Title: Oil Thermostat 92° Upgrade		
AG-SB-2021-03-C-EN	Effective Date: 22.07.2021	Compliance Category:
Applicability		A – MANDATORY B – RECOMMENDED C - OPTIONAL
Aircraft type & model: All AutoGyro models	Affected Serial number(s): All AutoGyro models	
The maintenance manual to be referenced is this stated or subsequent issue.		As per AutoGyro website
This form is the response from AutoGyro GmbH either against a problem found in the product in service requiring a containment or rectification action, or as service information for aircraft modification incorporation. For help, contact airworthiness@auto-gyro.com .

Reason and overview of the Service Bulletin (cause of problem if known)

Thermostat III (and previous thermostat versions, the replacement process is identical)

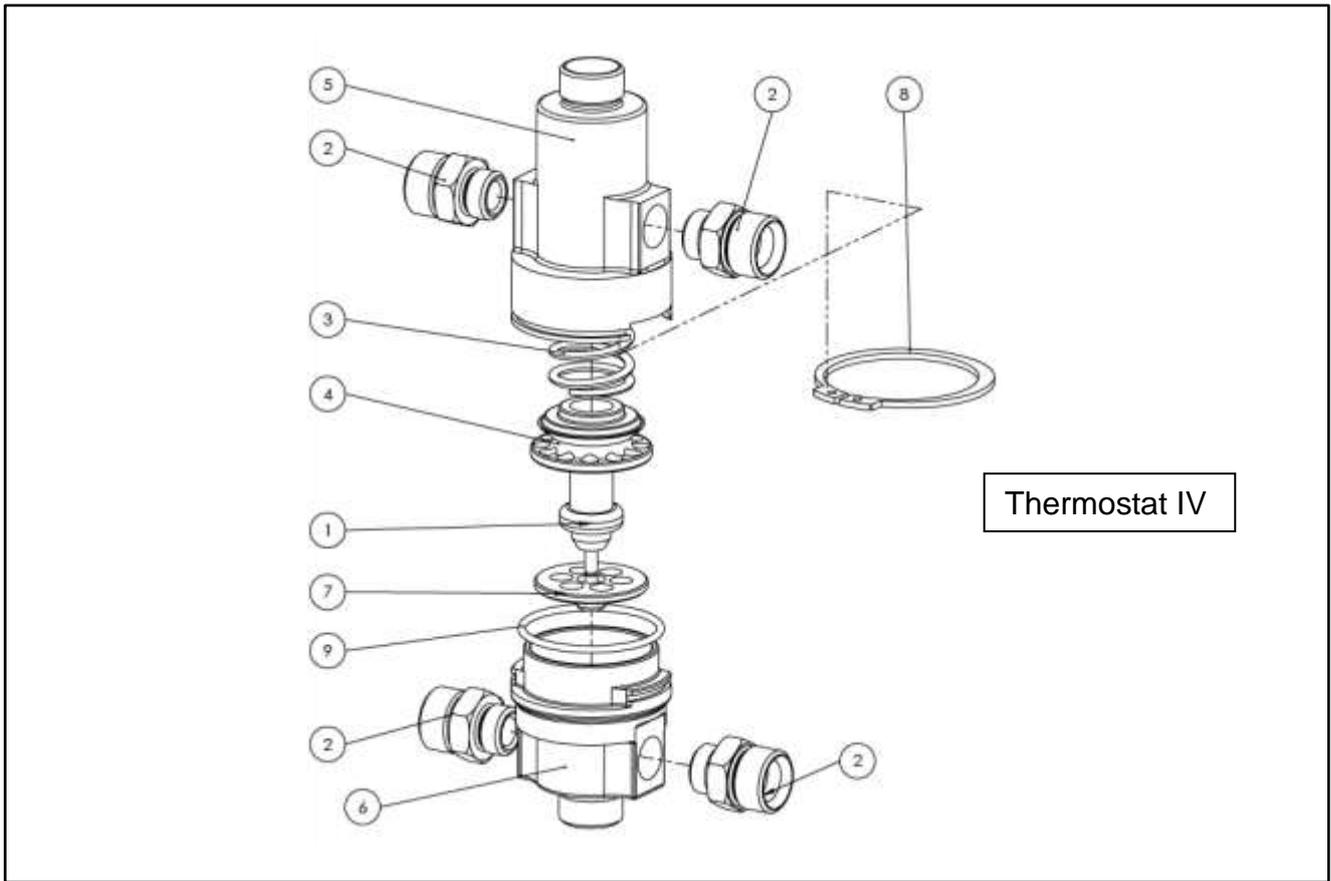
Through further research and lessons learnt in the market, predominantly in cold climate countries, AutoGyro has determined that a different oil thermostat (part no. 48159) calibrated to open at a higher oil temperature of 92°C provides improved oil temperature control.

5. Remove the screws (8) and nuts (9) securing the thermostat housing halves (1) & (3).
6. Separate the housing halves to gain access to the thermostat (4).
7. Remove the thermostat (4) and assemble the replacement item (48159).
8. Ensure the mating faces of the 2 thermostat housing halves are clean and degreased, and re-assemble with bolts (8) and new M5 SI nuts (9) (unless the remaining nylock prevailing torque is considered satisfactory by the engineer responsible) as per the original assembly.
